Recall Campaign Bulletin

Campaign No. 2022030015, March 2022

SUBJECT: Model GLE-Class (167 platform)

Replace Prefuse Box

Figure 1

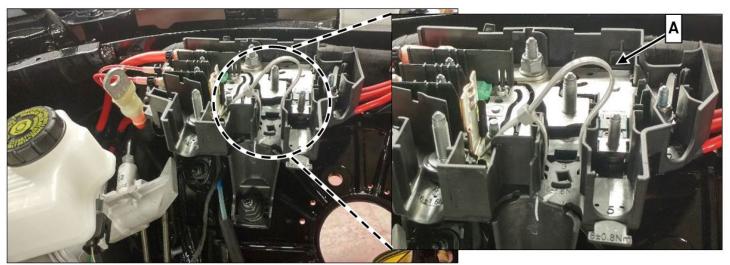
- 1. Switch off ignition and keep transmitter keys outside of transmitter range (at least 2 meters / 6.6 feet).
- 2. Remove cover for left air/water duct above prefuse box in engine compartment.
 - For basic data, see **AR54.15-P-1330ME**, operation step 2.
- **3.** Remove cover of prefuse box in engine compartment.
 - **i** For basic data, see **AR54.15-P-1330ME**, operation step 3.
- **4.** Check whether there is a cable tie **(A)** for the supply line from the alternator to the prefuse box in the engine compartment at connection 3 **(Figure 1)**.

- **a.** Cable tie at connection 3 of prefuse box **not** present: Carry out **work procedure**.
- Cable tie at connection 3 of prefuse box present:
 Assemble in reverse order and end measure.

Figure 2

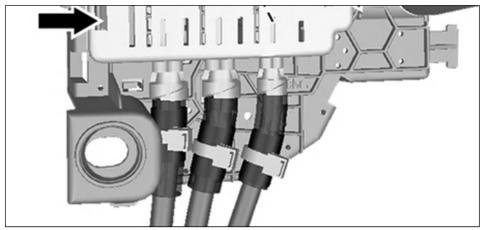
- 1. Replace prefuse box in engine compartment.
 - <u>i</u> For basic data, see **AR54.15-P-1330ME**.
 - $|\mathbf{i}|$ The cable tie for the supply line at connection 3 of the prefuse box is included in the delivery package.
 - i The cable ties for the remaining electrical cables must be replaced (Figure 2).
 - i The number of electrical cables varies depending on the vehicle equipment.
